**BEACON PLANNING BOARD**  
**One Municipal Plaza - Courtroom**  
**BEACON, NEW YORK 12508**  
*Phone (845) 838-5002 Fax (845) 838-5026*

The Planning Board will meet on **Tuesday, February 9, 2016** in the Municipal Center Courtroom. A training workshop will take place at 7:00 p.m. and the regular meeting will begin at 7:30 p.m.

Mr. Jay Sheers, Chairman  
and Members of the Planning Board  
City of Beacon  
One Municipal Plaza  
Beacon, NY 12508

Re: Response to Engineer and Consultant Comments

## Sheet 1 of 8 - Site Plan

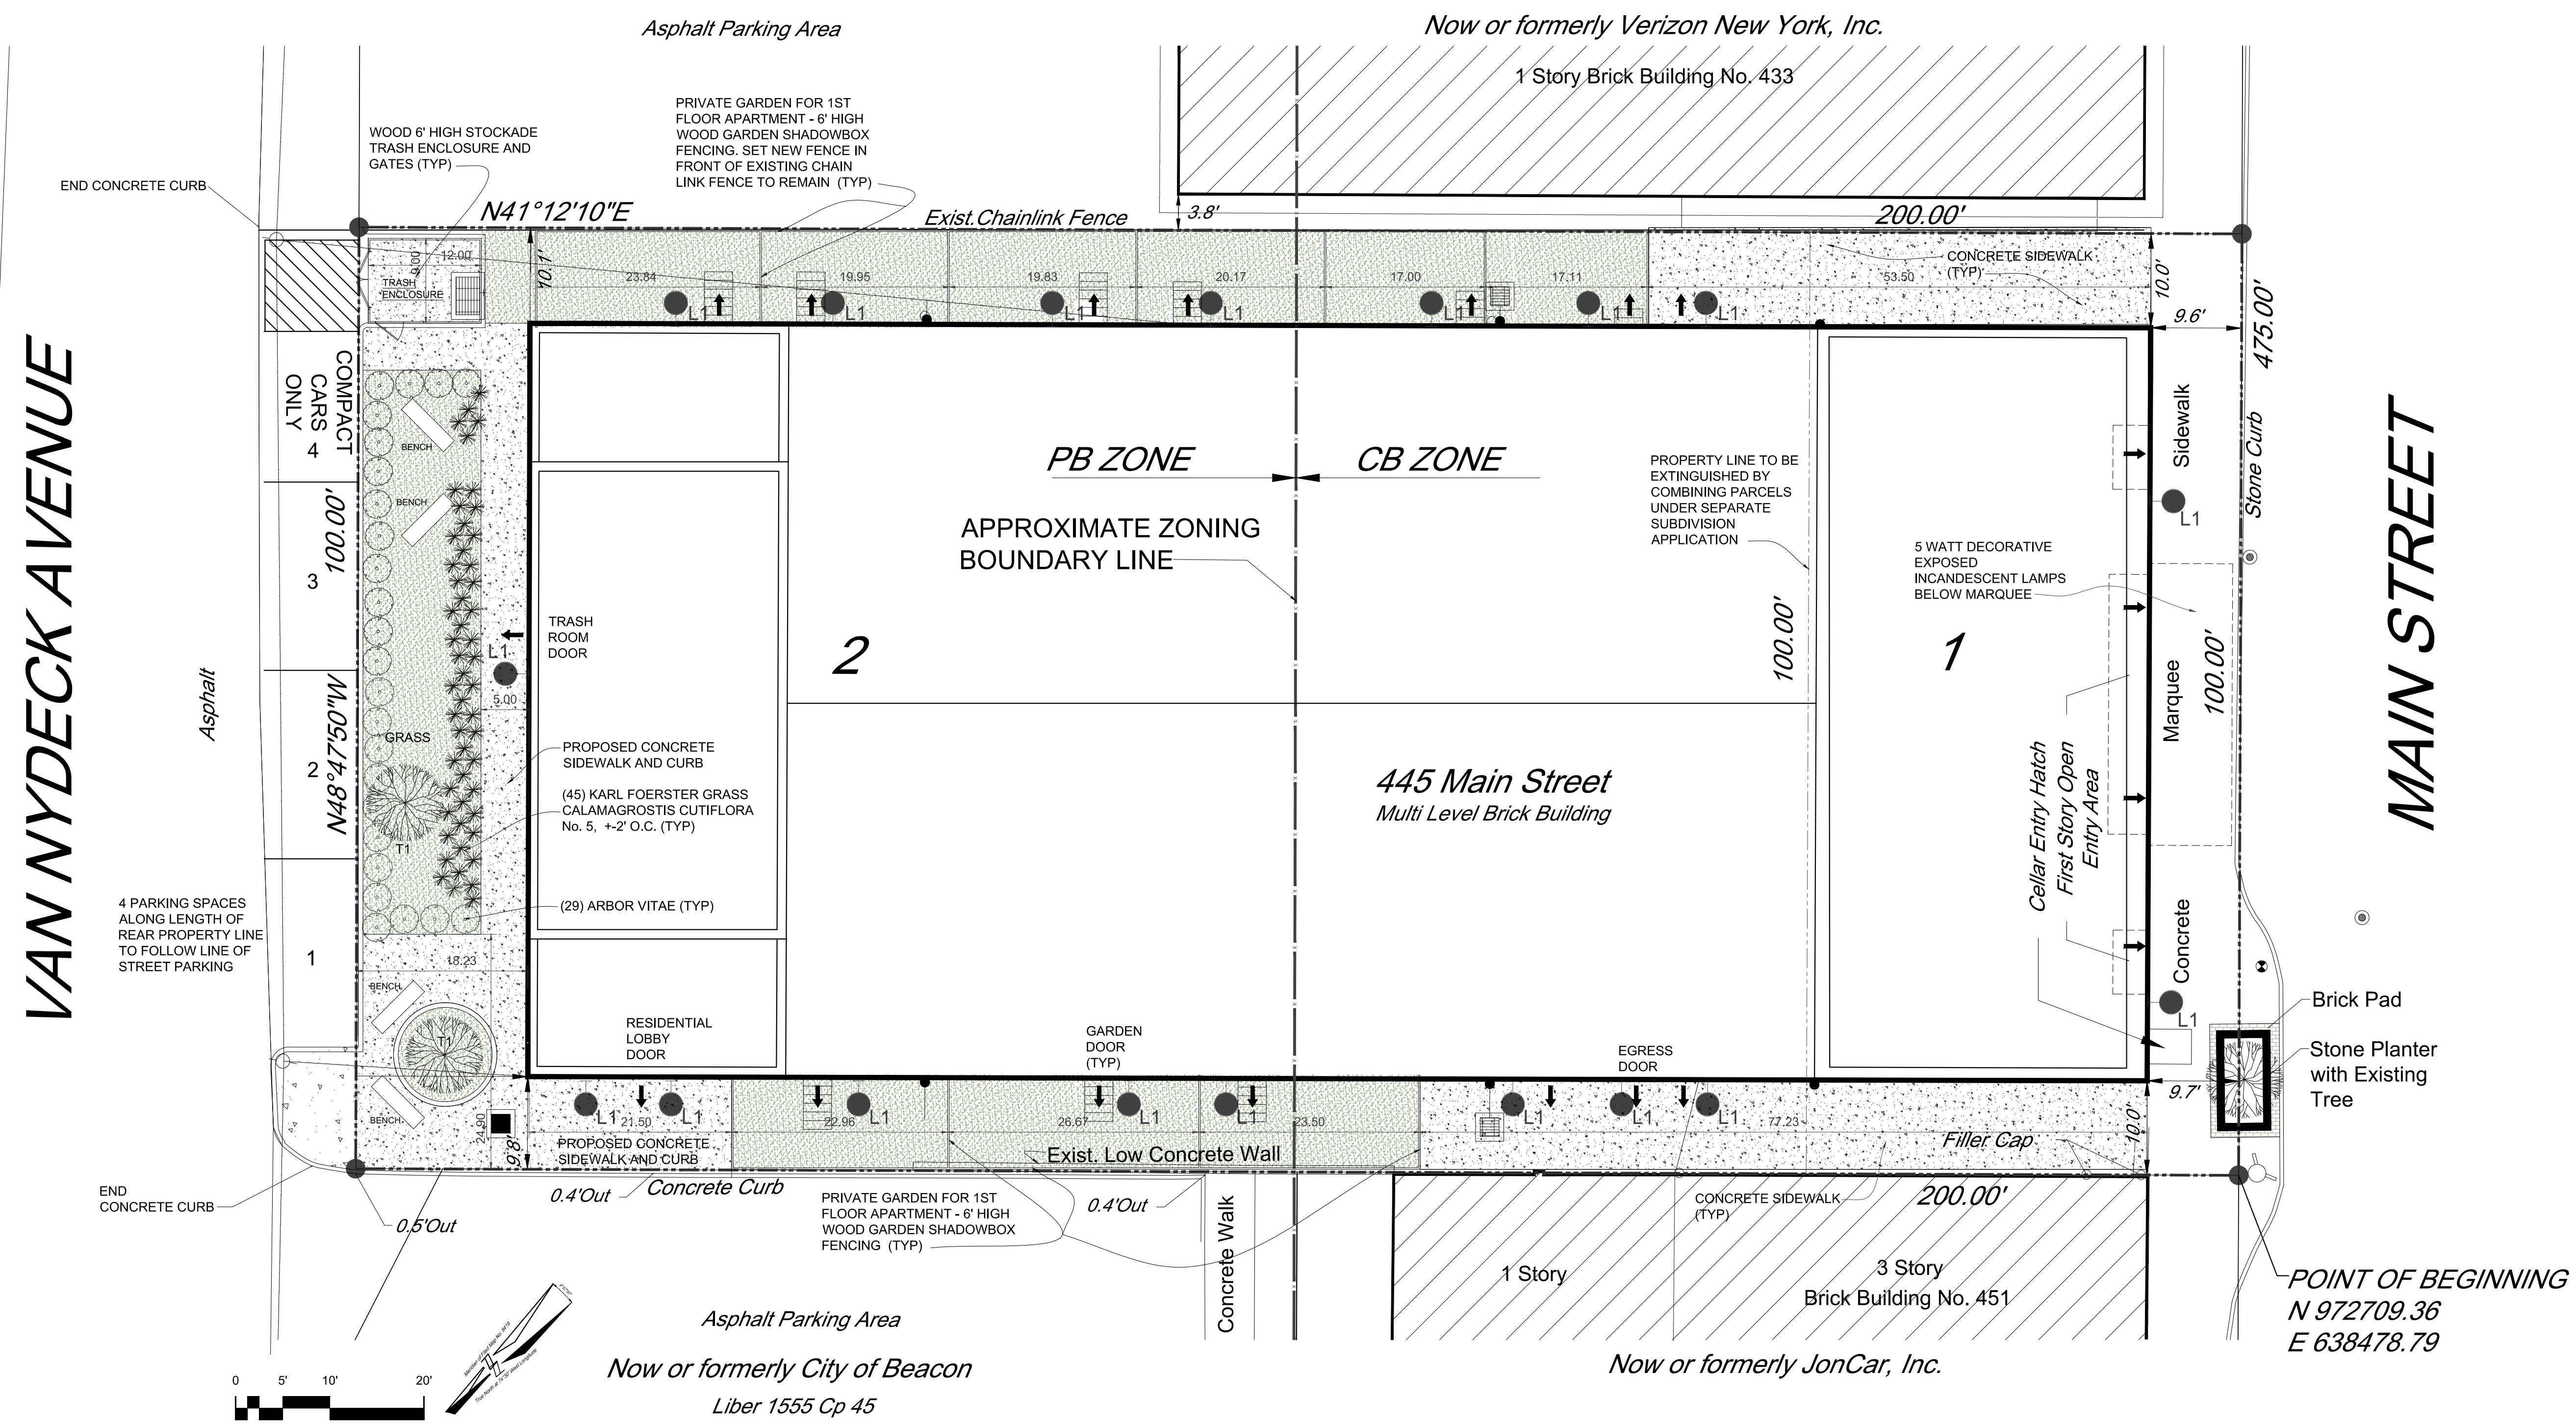
1. **Comment:** Sheet 1 of 8 should show the location of the 5 proposed parallel, parking stalls to be striped along Van Nydeck.

**Response:** Proposed striping is shown on the site plan for a total of 4 spaces along the property line.

**Site Plan Application**  
Sheet 6 of 8 - Landscape, Lighting Details, Marquee

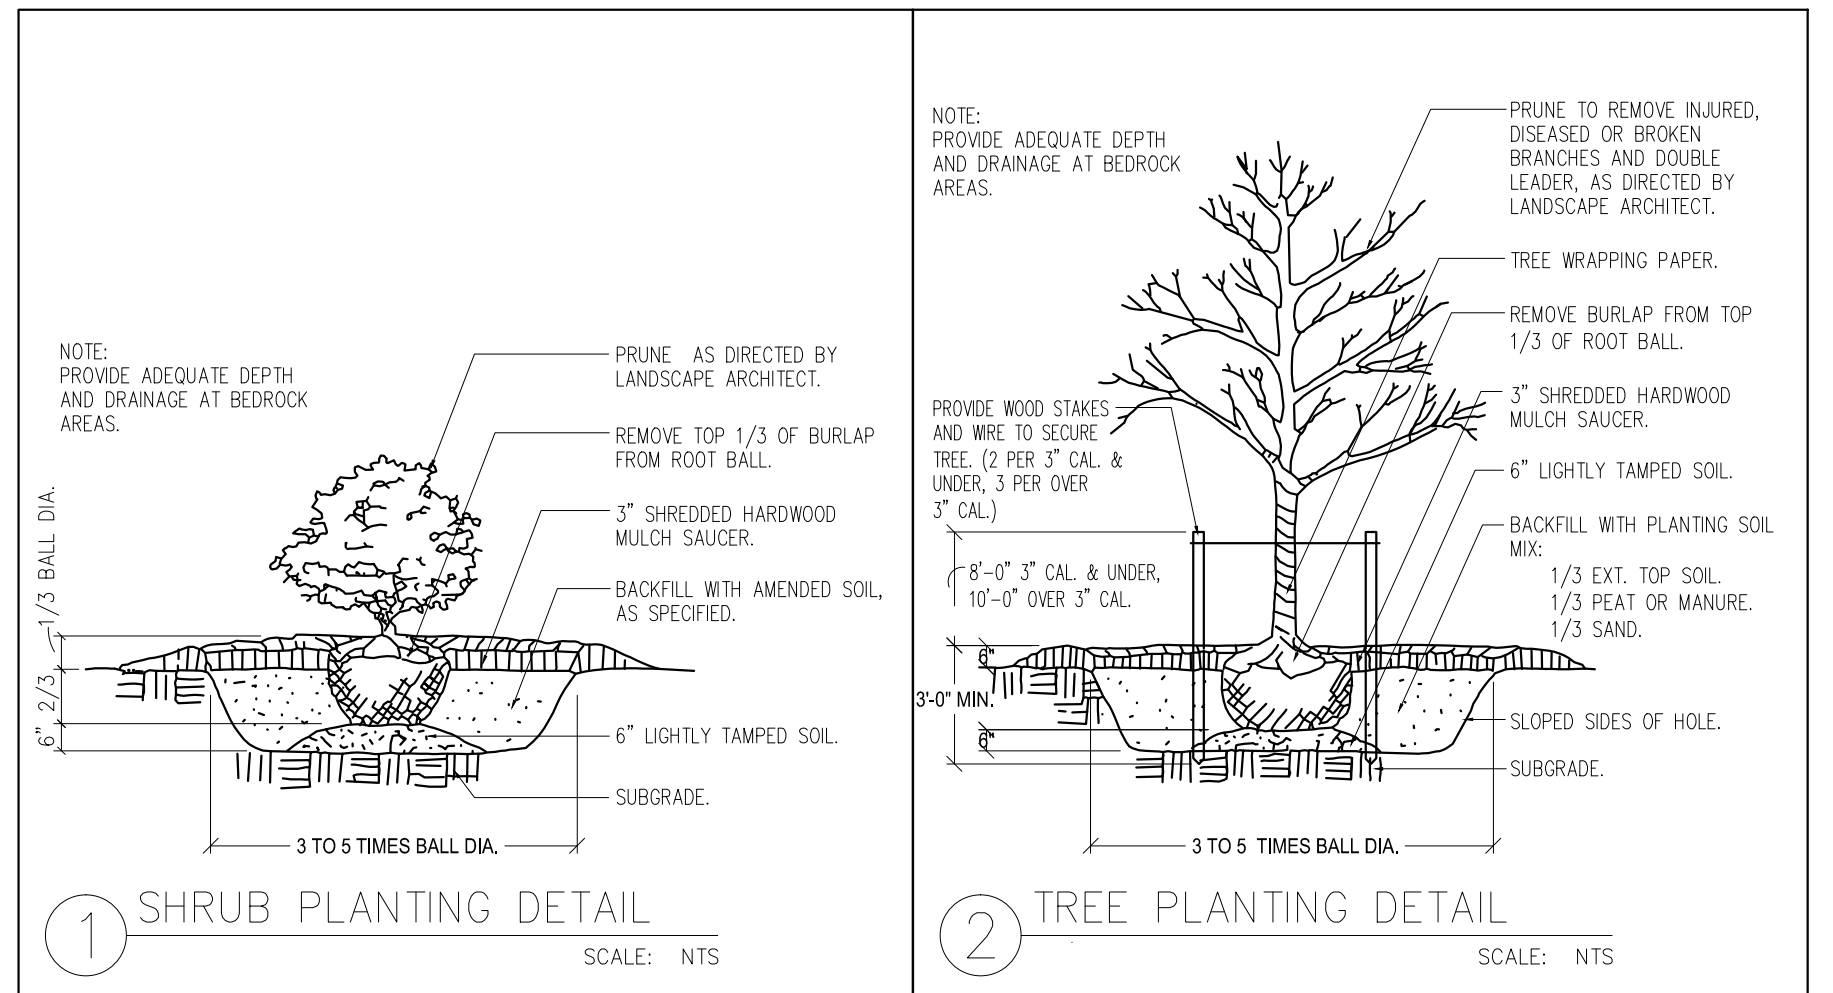
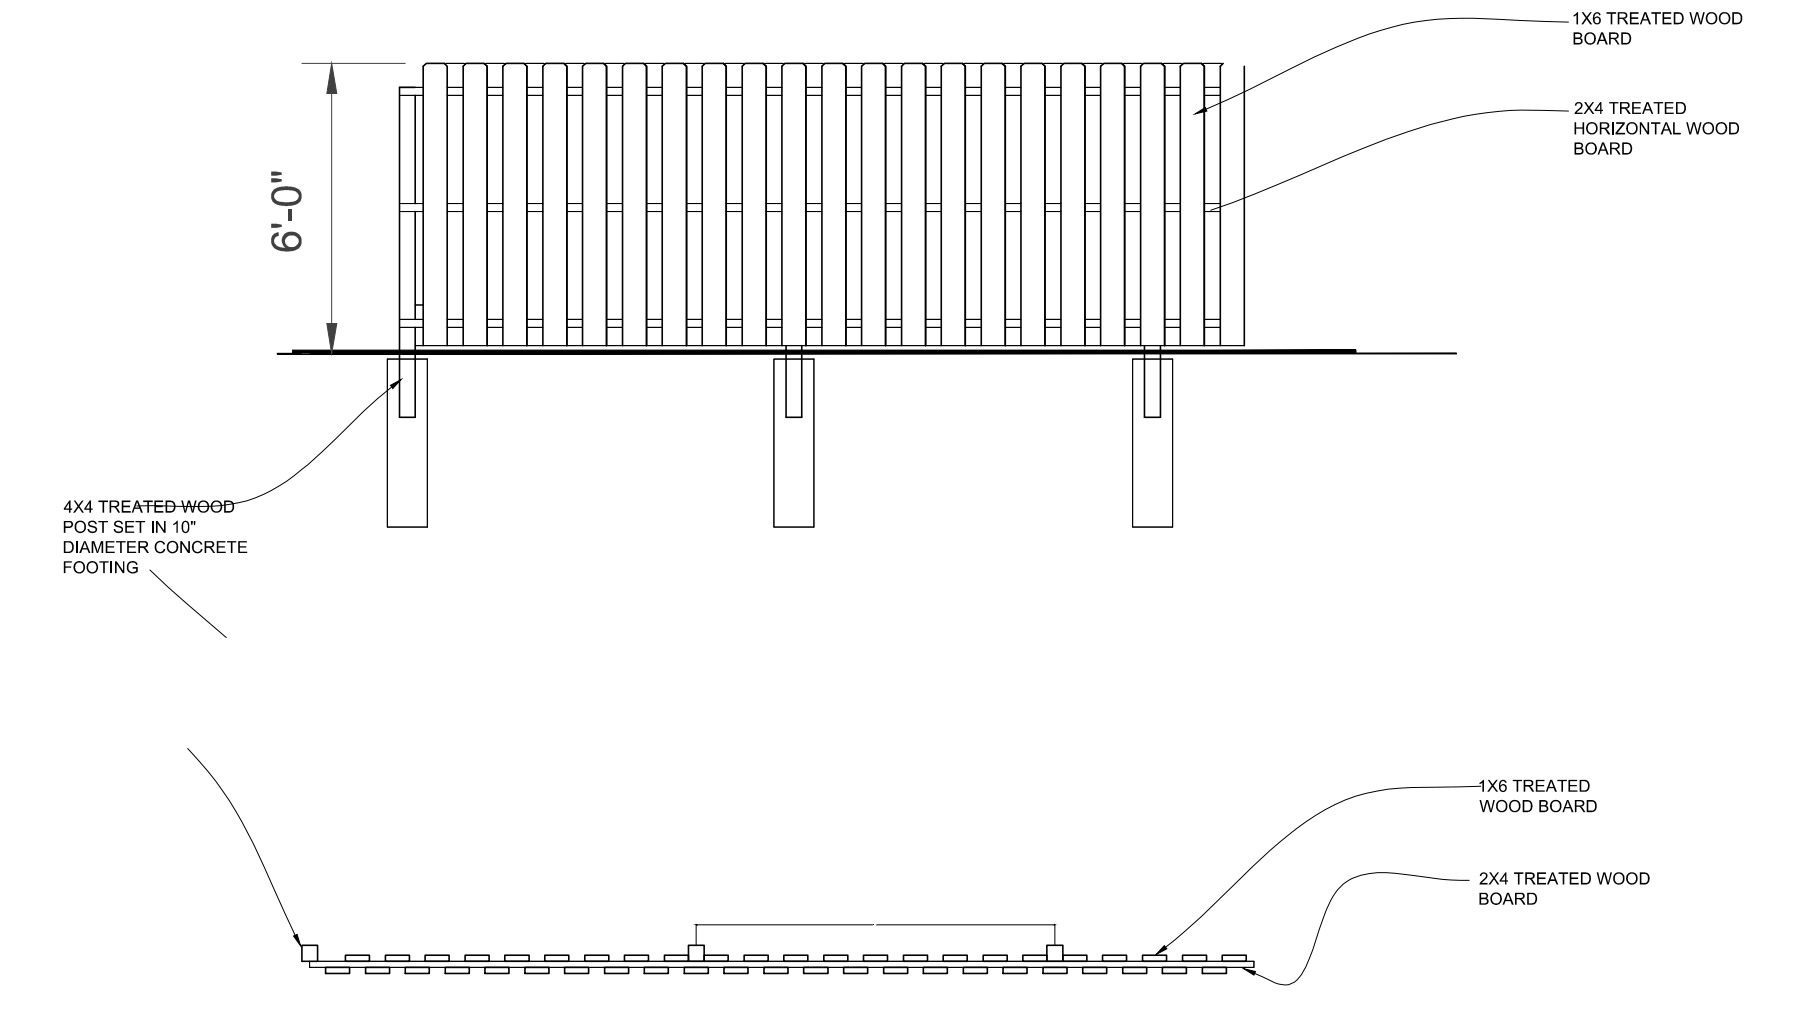
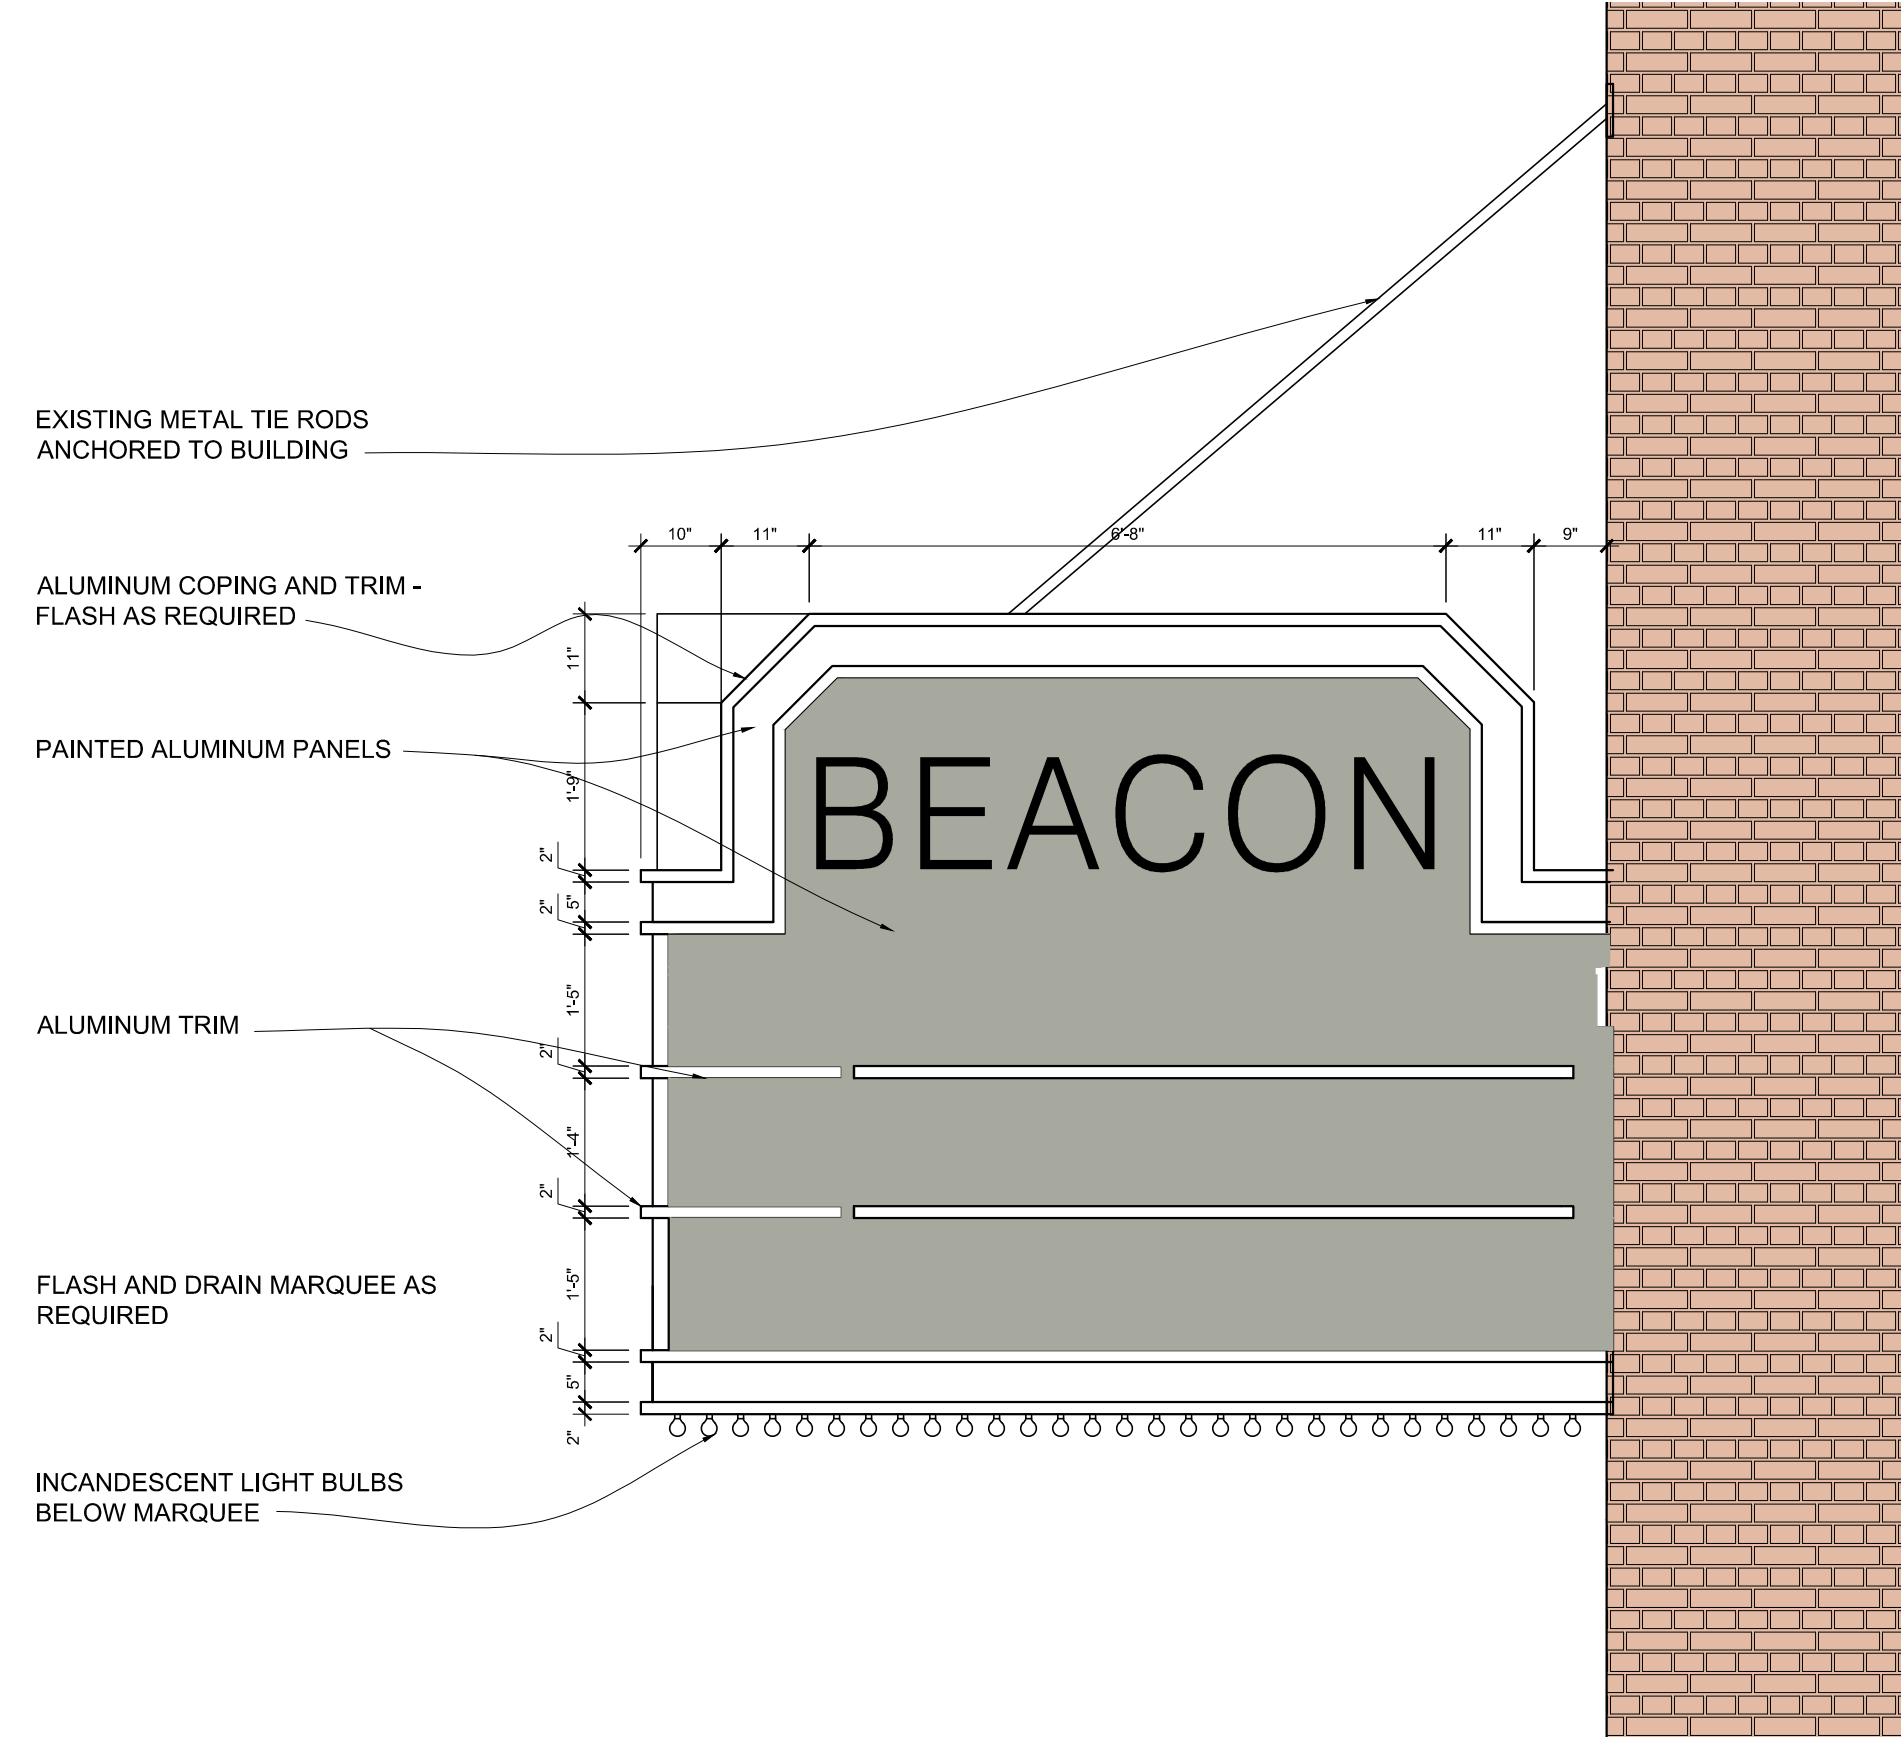
2. **Comment:** Sheet 6 of 8, the "Landscape, Lighting Details, Marquee" plan should be updated to provide construction details for the proposed plantings in the rear of the building, as shown on Sheet 1.

**Response:** Construction details for the proposed planting has been provided on Sheet 6 of 8.
